PRODUCT CHANGE NOTIFICATION (PCN)

A-MCUP-80050
MODULAR CABLE

CHANGE NOTIFICATION: PCN 20220425_A-MCUP-80050

DESCRIPTION OF CHANGES:
CHANGE OF DATA SHEET
CHANGE OF DATA SHEET
New Draw.-No. ASS_7407_CArev04

A-MCUP-80050 OLD VERSION

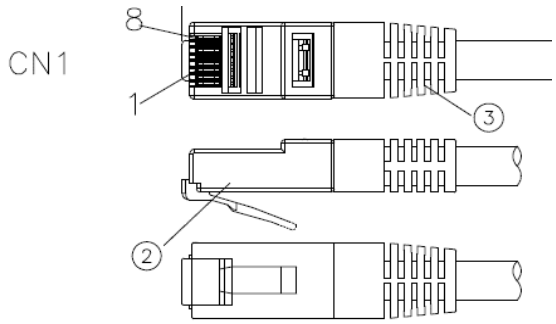
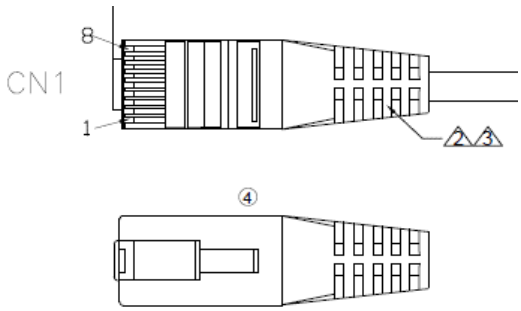
REASON FOR CHANGE:
CHANGE OF PRODUCT LOCATION
CHANGE OF PRODUCT LOCATION

NO.	NAME.	Q'TY	SPECIFICATION
③	Molding PVC	2	Molding PVC 45P
②	RJ45 CONN	2	RJ45 8P8C,Two Fork gold plated contacts 3u" gold
①	CABLE	1	UTP(26AWG*x1PR)*4+PVC OD:4.9±0.2mm

NO.	NAME.	Q'TY	SPECIFICATION
④	3 Molding PVC	2	Molding PVC 65P
④	2 RJ45 CONN	2	RJ45 8P8C, contacts 3u" gold-plated Un-shielded PC UL94V-2
④	1 CABLE	1	CAT 5E U/UTP(26AWGx1PR)*4+PVC Jacket OD:4.9±0.2mm

Drawing-No.
ASS 7407 CA

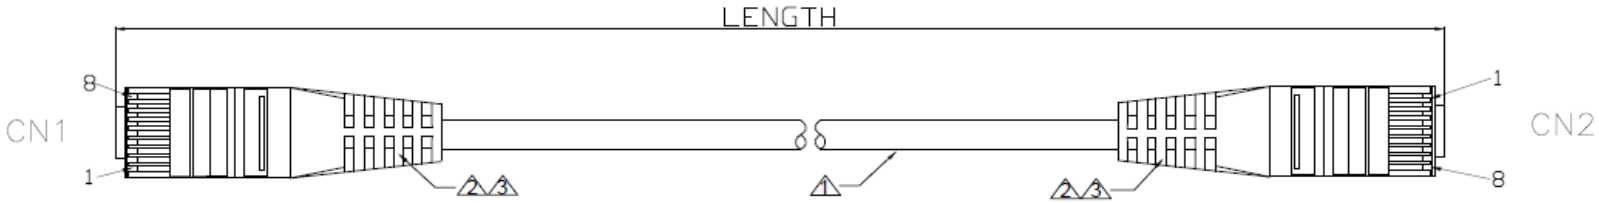
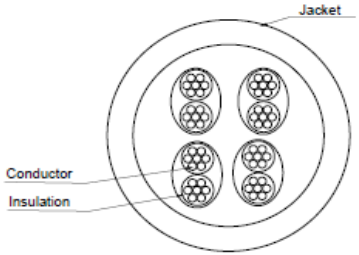
Id.	Modification	Date	Name		Date	Name
④	Change the plant	12.04.2022	Luca	Drawn	25.05.2014	Joanna
③	Clarify the tolerance	23.08.2018	Segal	Approved	12.04.2022	Luca
②	Add the new P/N for black outer jacket	01.11.2017	Winnie			
①	Add the product type of length and color	04.08.2017	Fred			
⓪	Drawn	25.05.2014	Joanna

NO.	NAME.	Q'TY	SPECIFICATION
④ ③	Molding PVC	2	Molding PVC 65P
④ ②	RJ45 CONN	2	RJ45 8P8C, contacts 3u" gold-plated Un-shielded PC UL94V-2
④ ①	CABLE	1	CAT 5E U/UTP(26AWGx1PR)*4+PVC Jacket OD:4.9±0.2mm
